Specification Mintech./CV2362 - CV2368
 Issue 2A, Dated September 1967
 To be read in conjunction with K1001
 ignoring clauses:- 5.2, 5.3, 5.8.

Type of Valve:- Magnetron
 Cathode:- Indirectly heated
 Envelope:- Metal glass
 Prototype:- M525

SPECIFICATION Mintech./CV2362-CV2368, ISSUE 2A, DATED SEPTEMBER 1967.

AMENDMENT No.1

Page 5. Outline Drawing.

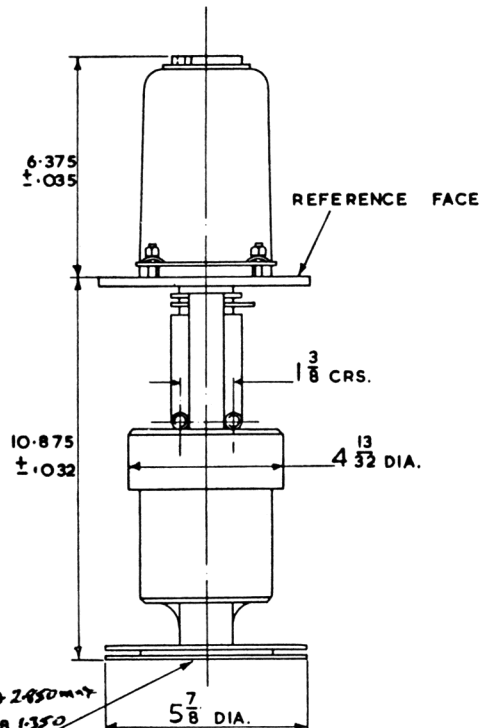
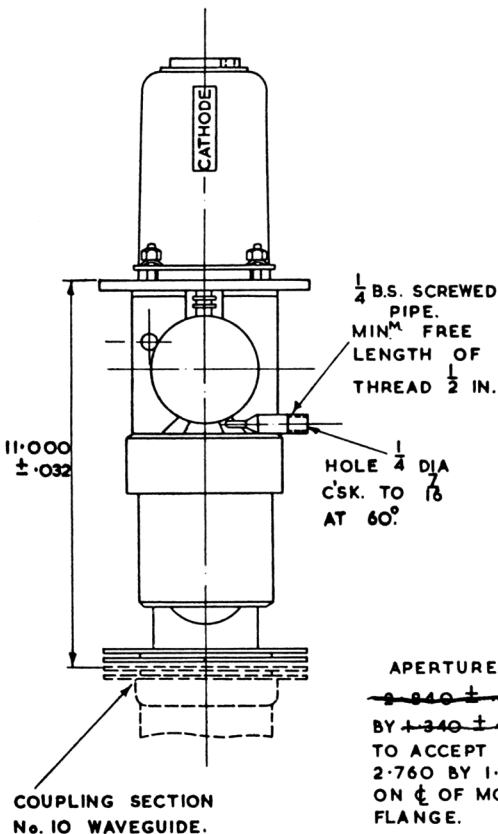
View in top right hand corner.

The flange diameter is shown as "6.000 Dia + .000"
- .000
which should be amended to read "6.000 Dia + .000"
- .010.
